Powder River Basin Resource Council

April 23, 2020

Re: Objections to Brook Mining Co., LLC Coal Mining Permit Application & Comments on the Department of Environmental Quality Draft Cumulative Hydrologic Impact Assessment

FIGURE 2 NEW PROPOSED MINE PLAN OF THE BROOK MINE SHOWING THE ADJACENT OLD WORKS

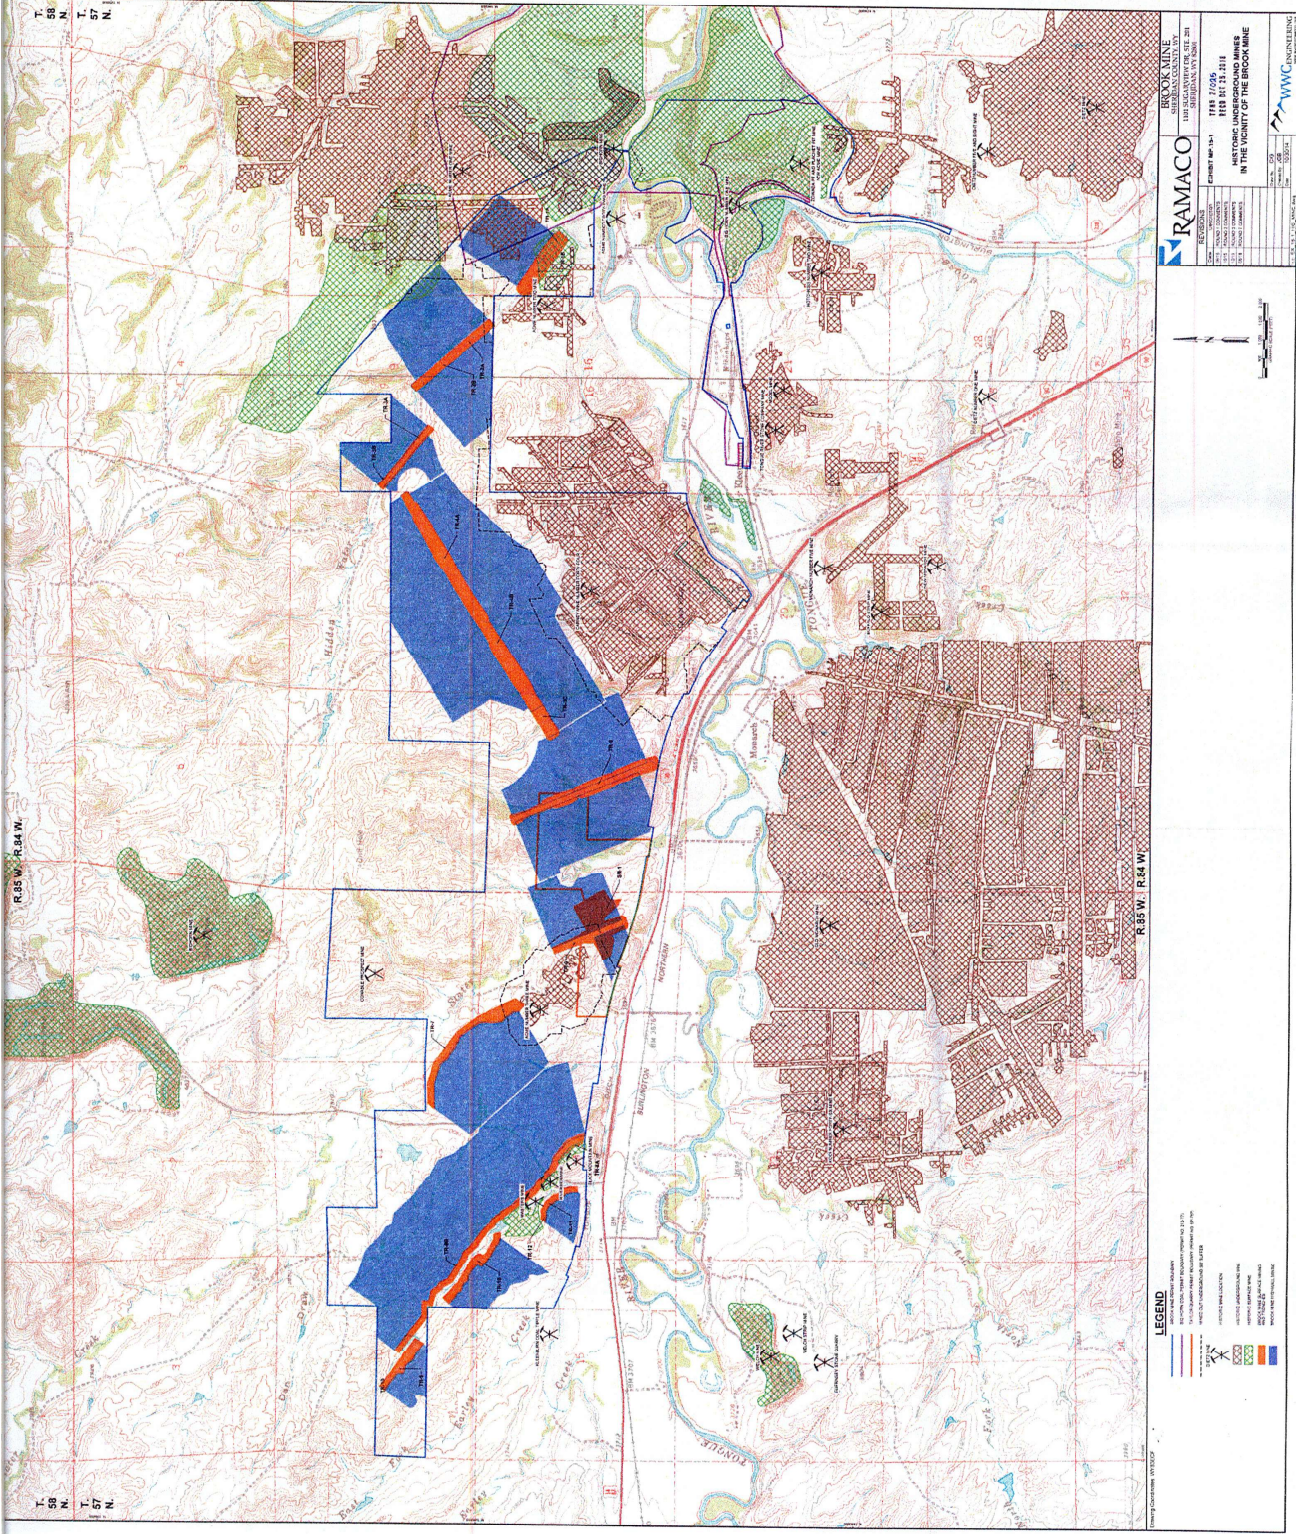
The new proposed HWM TR-1 area consists of only one block (in lieu Blocks 3 and 4 formerly TR-2, see MEA, 2017). The new mine plan is shown in Figure 2. Comparing Figure 4.3 (MEA, 2017) to Figure 2, it appears the changes in the mine plan only pertain to the old TR-1 and TR-2 areas. Consequently, the HWM areas which were Blocks 9 and 16 in Figure 4.3 still abut against old workings with minimum barrier coal of 0 to 70 ft. and consequently result in potentially flooding from the old workings to the south especially considering the likely inaccuracies of the mine map of the old works. Based on historical mapping, the floor depths in the minimum barrier areas are about 87 to 115 ft. in the new TR-4B, 5, and 7 areas. See Figure 2. Based on various empirical relationships on the minimum confirmed barrier thickness, this barrier should be at least about 55 to 110 ft. (Koehler and Tadolini, 1995), and therefore all areas (TR-4B, 5, and 7) would exceed the

FIGURE 3 SKETCHES OF THE THREE PRINCIPAL MODES OF FAILURE OF ROOM-AND-PILLAR MINE WORKINGS WHICH CAN RESULT IN SURFACE SUBSIDENCE

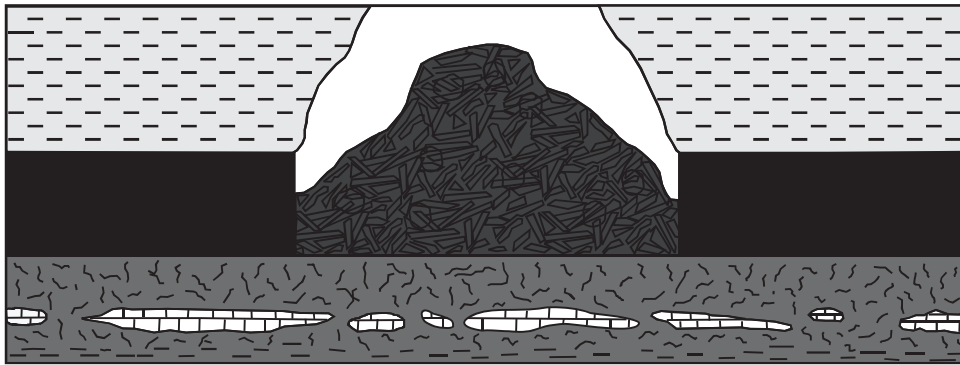
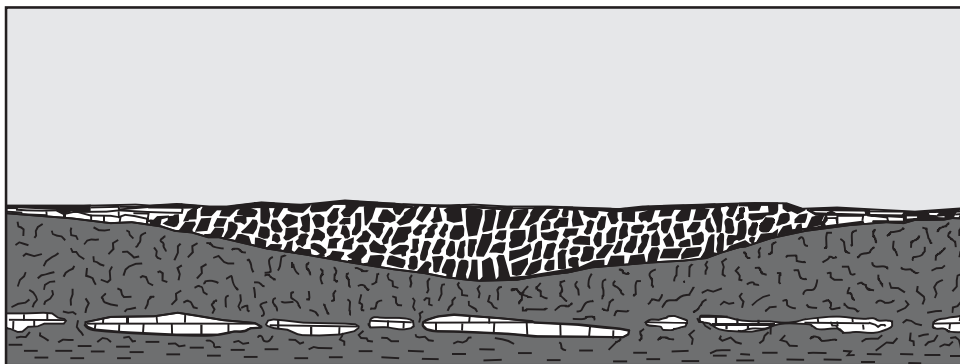
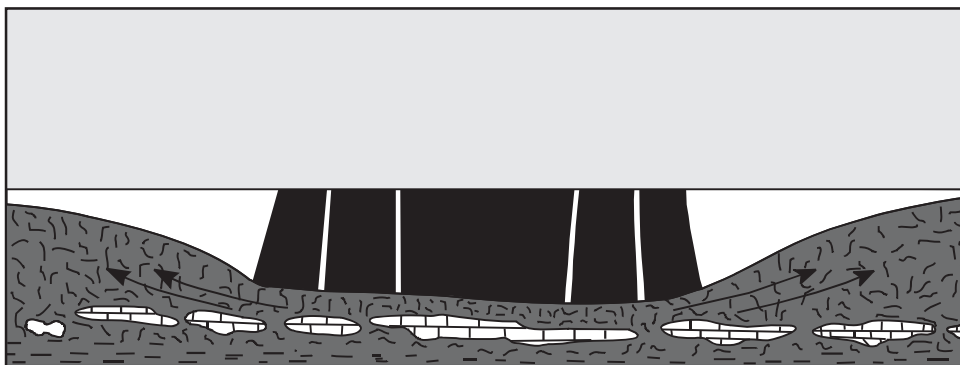
Below is the review of limited AAI mine design analyses against mine roof, pillar and floor failure based on the information available in the AAI report. See Figure 3.

FIGURE 2 NEW PROPOSED MINE PLAN OF THE BROOK MINE SHOWING THE ADJACENT OLD WORKS

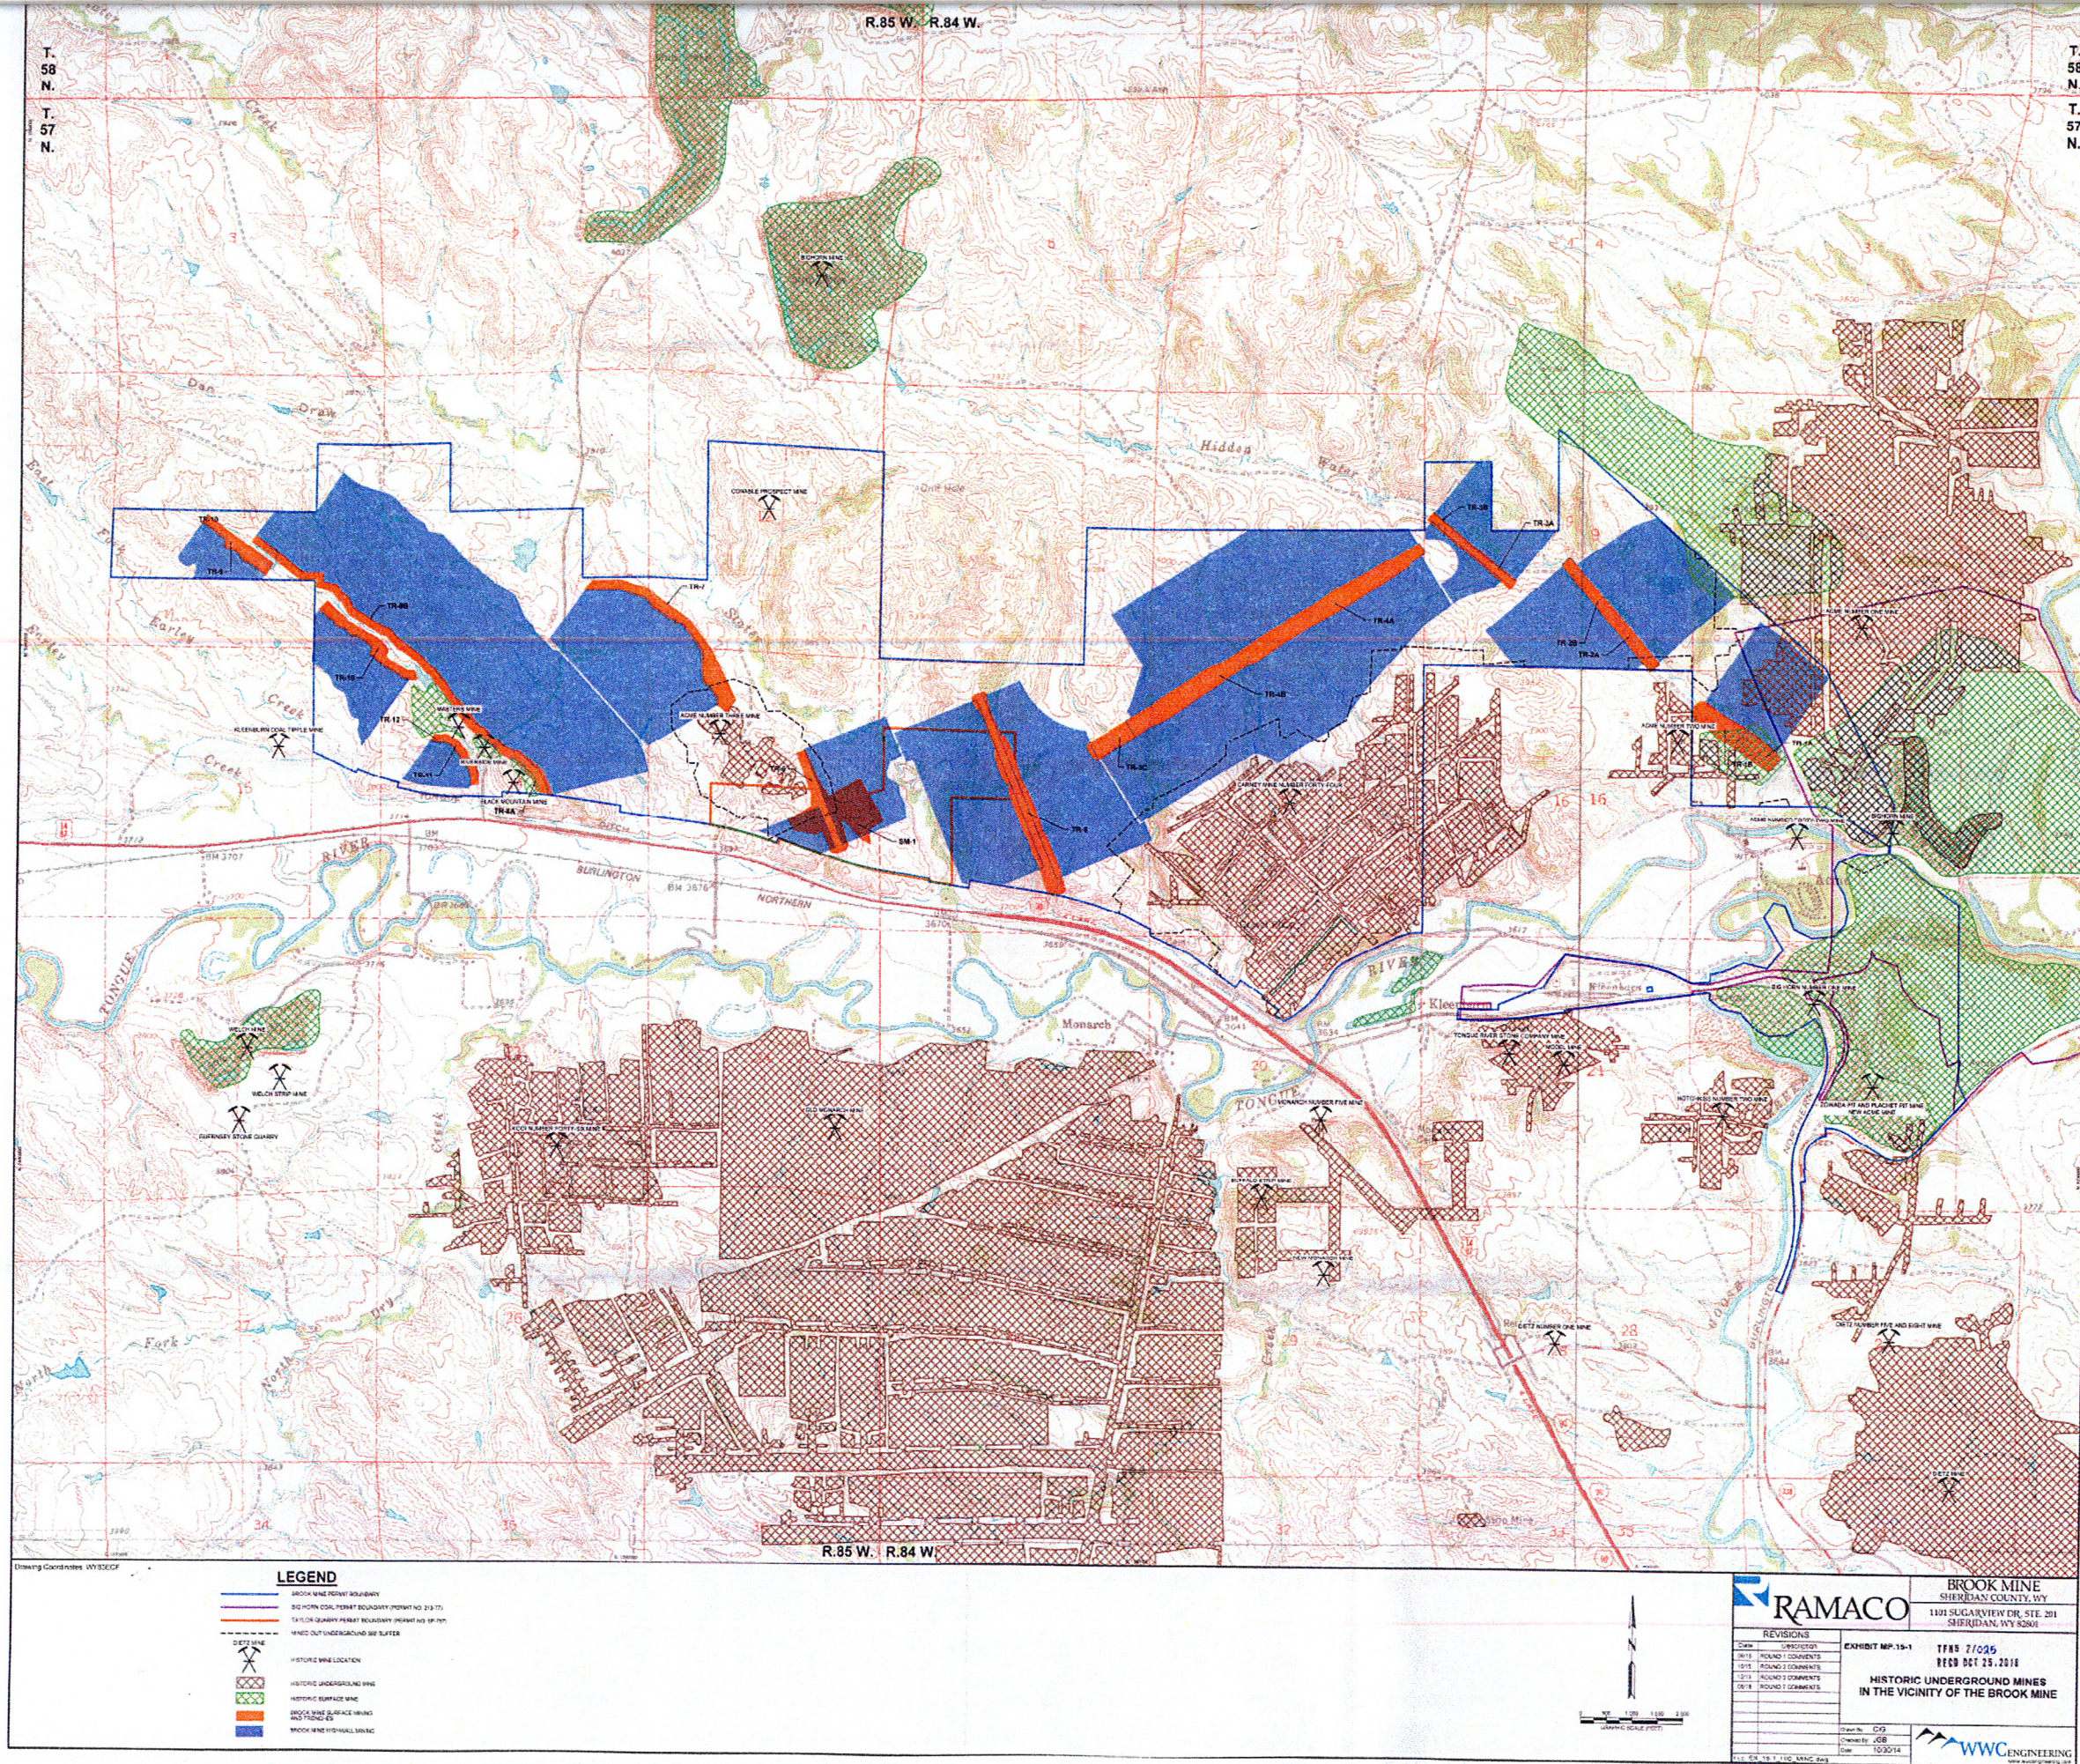
The new proposed HWM TR-1 area consists of only one block (in lieu Blocks 3 and 4 formerly TR-2, see MEA, 2017). The new mine plan is shown in Figure 2. Comparing Figure 4.3 (MEA, 2017) to Figure 2, it appears the changes in the mine plan only pertain to the old TR-1 and TR-2 areas. Consequently, the HWM areas which were Blocks 9 and 16 in Figure 4.3 still abut against old workings with minimum barrier coal of 0 to 70 ft. and consequently result in potentially flooding from the old workings to the south especially considering the likely inaccuracies of the mine map of the old works. Based on historical mapping, the floor depths in the minimum barrier areas are about 87 to 115 ft. in the new TR-4B, 5, and 7 areas. See Figure 2. Based on various empirical relationships on the minimum confirmed barrier thickness, this barrier should be at least about 55 to 110 ft. (Koehler and Tadolini, 1995), and therefore all areas (TR-4B, 5, and 7) would exceed the

FIGURE 3 SKETCHES OF THE THREE PRINCIPAL MODES OF FAILURE OF ROOM-AND-PILLAR MINE WORKINGS WHICH CAN RESULT IN SURFACE SUBSIDENCE

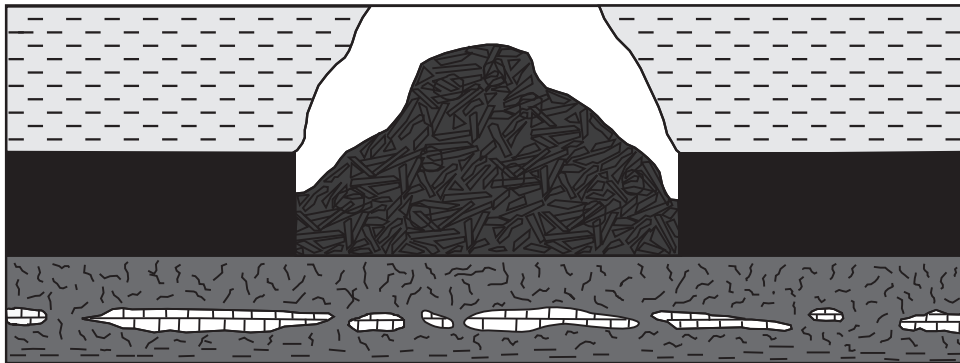
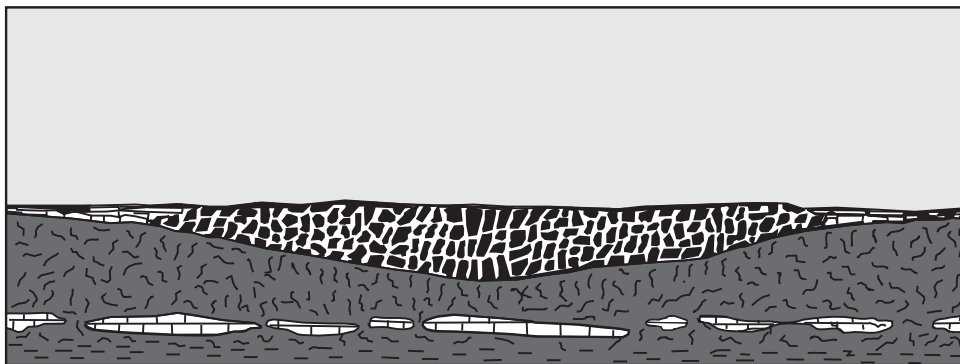
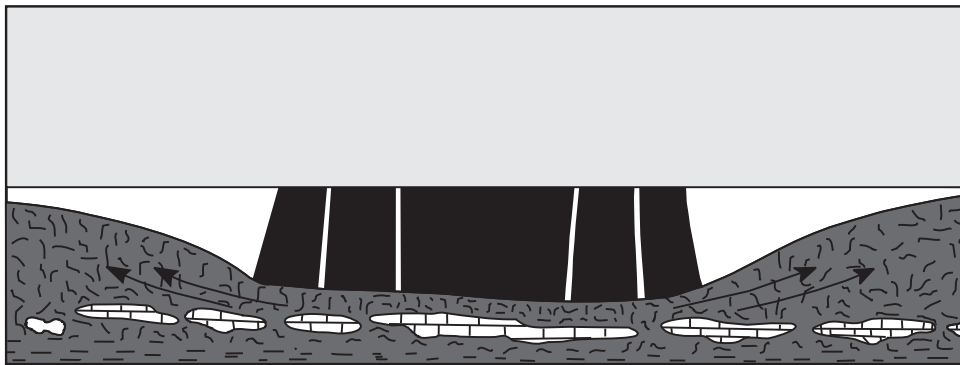
Below is the review of limited AAI mine design analyses against mine roof, pillar and floor failure based on the information available in the AAI report. See Figure 3.
